## DECISION OF THE PLANNING COMMISSION

**CLASS 3 DESIGN REVIEW / CLASS 3 SITE PLAN REVIEW / CLASS 2  
DRIVEWAY APPROACH PERMIT / TREE REGULATION VARIANCE CASE NO.  
DR-SPR-DAP-TRV18-07**

**SUMMARY:** Proposed development of a new 111-unit apartment complex.

**LOCATION:** 1881 Wiltsey Road SE, Salem, OR 97306

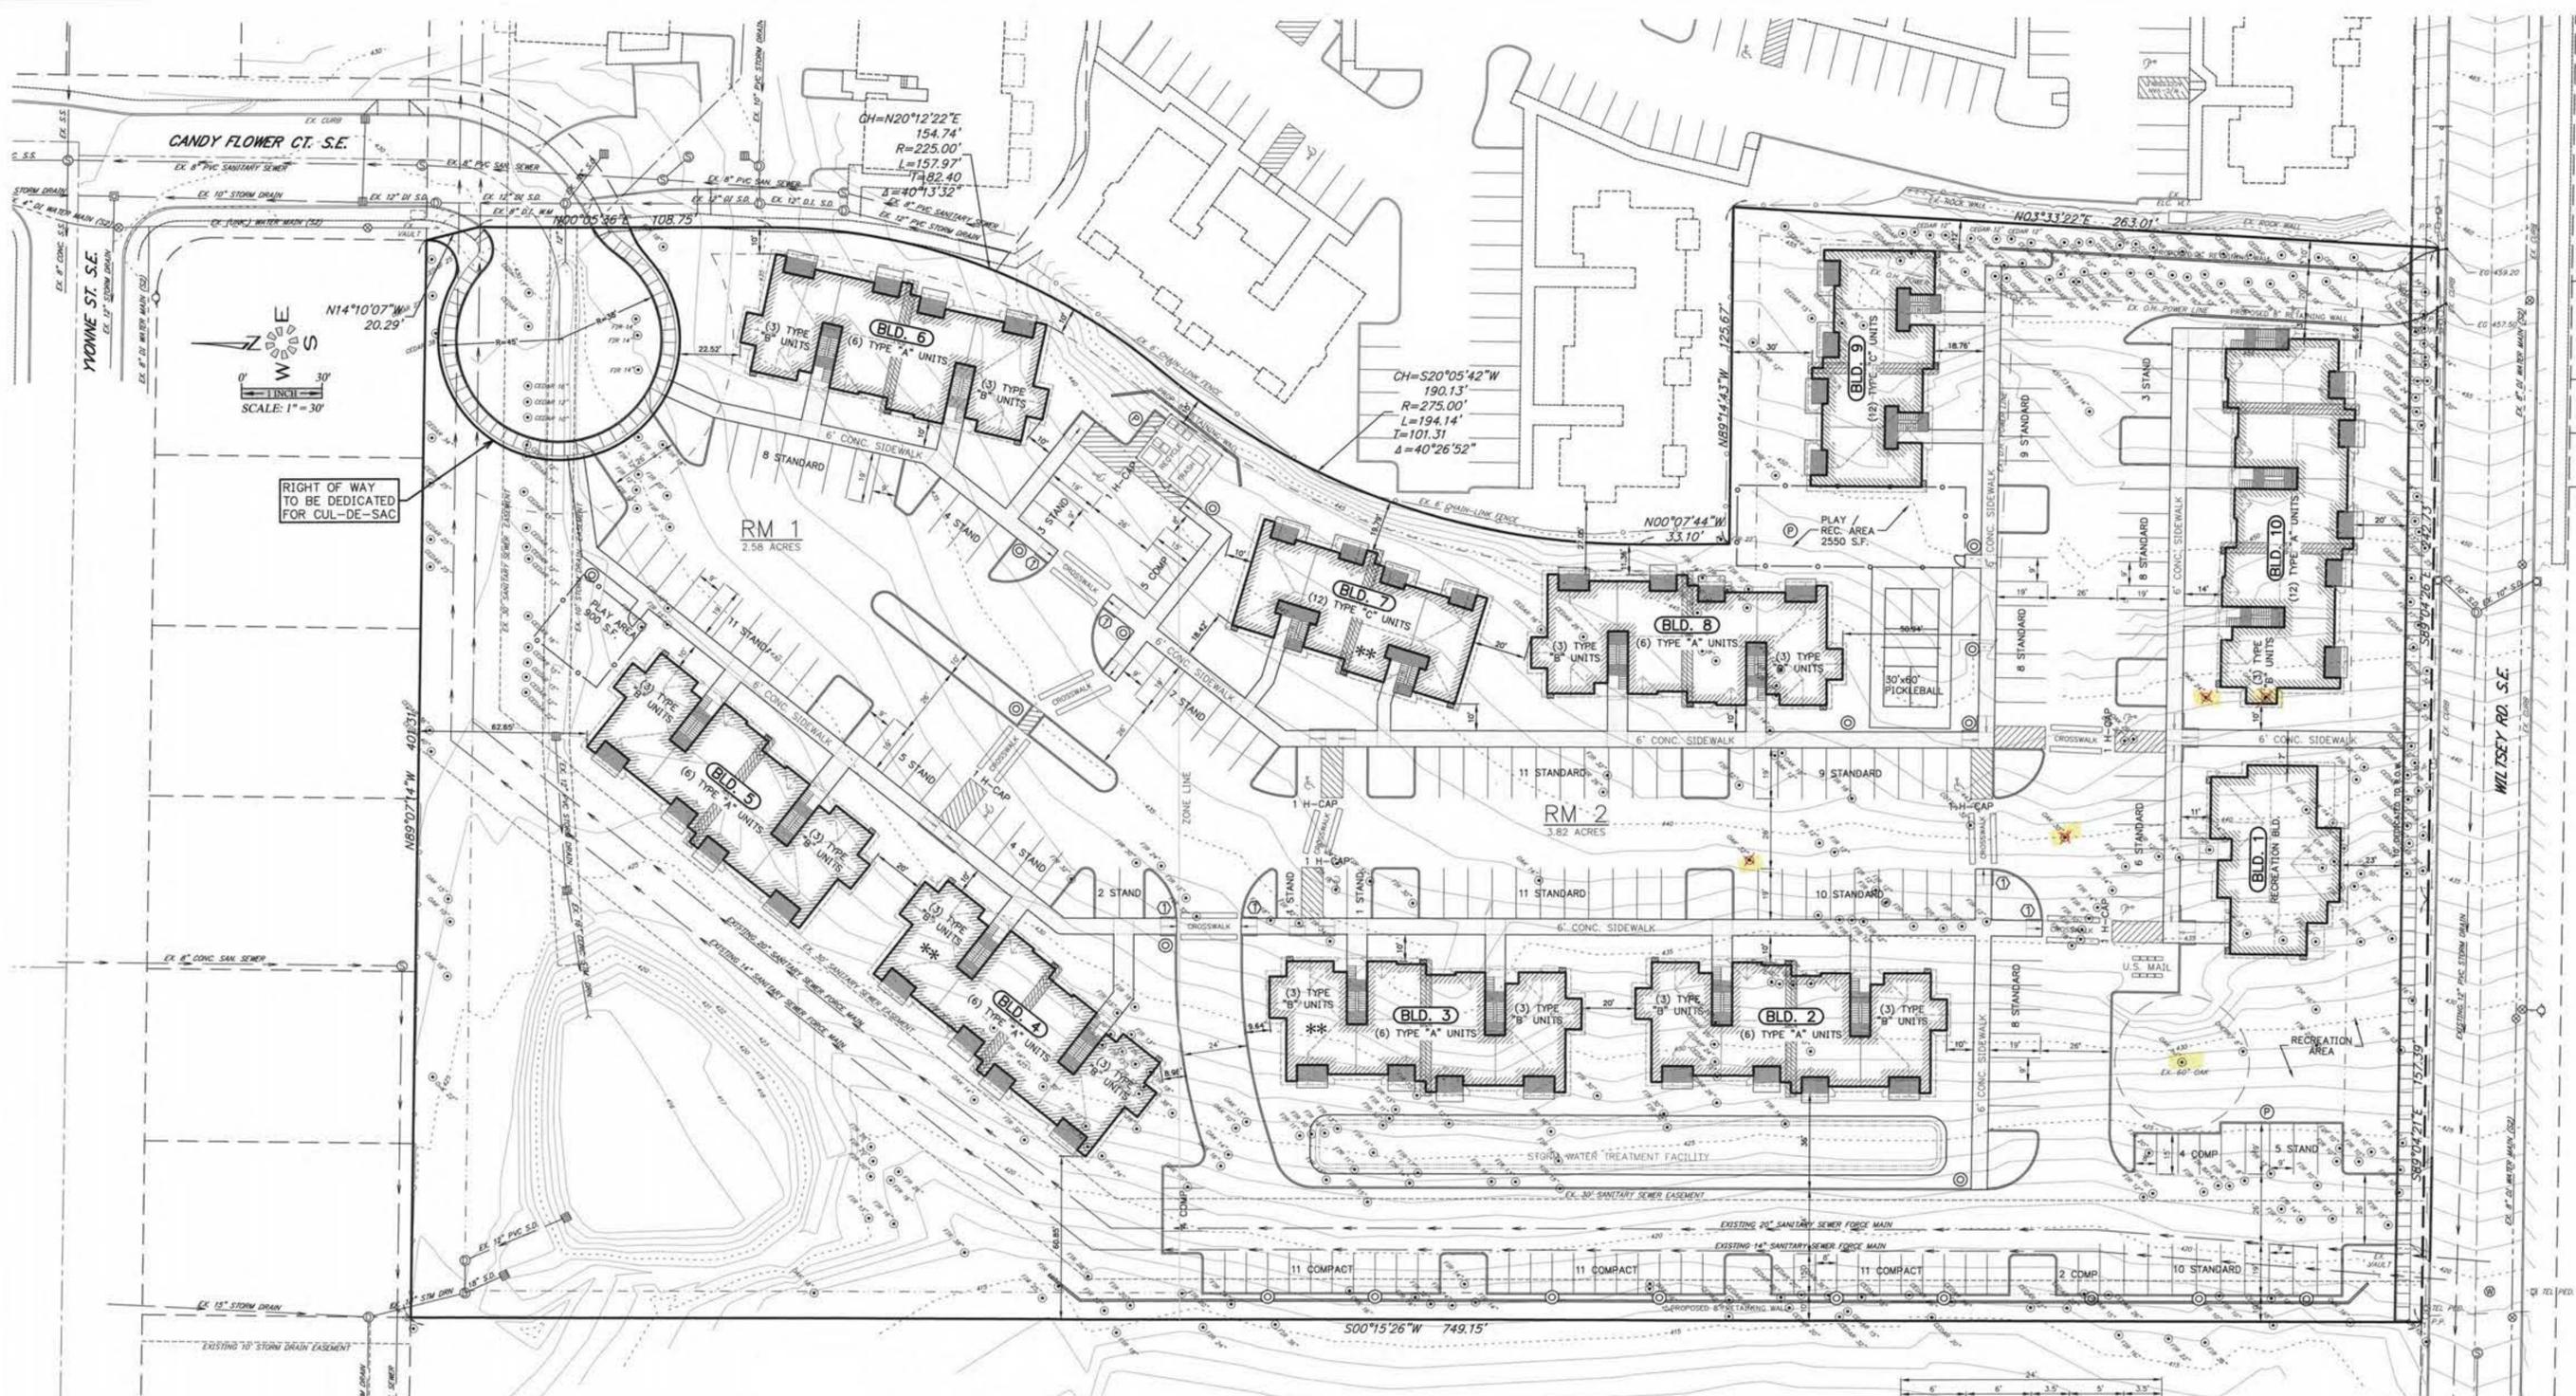
The 40" Oregon White Oak designed for removal is located within the building envelop of Building 10. In order to preserve that tree Building 10 would have to be moved, which would then affect the required setbacks and circulation. The moving of Building 10 would create a

The 24" Oregon White Oak designed for removal is located to the north of Building 10. The construction of Building 10 along with grading will affect this tree and make it difficult to preserve.

The 30" and 32" Oregon White Oaks designed for removal are located within the parking and accessways. The easement located along the southwestern property line creates a hardship in providing an alternate layout for the buildings and access. Therefore, these two trees must be removed to accommodate parking and adequate maneuvering areas within the accessways.

**Condition 12:** A minimum of eight Oregon White Oaks (*Quercus garryana*), with a minimum caliper of 2", shall be incorporated into the landscape design and replanted for the proposed development.
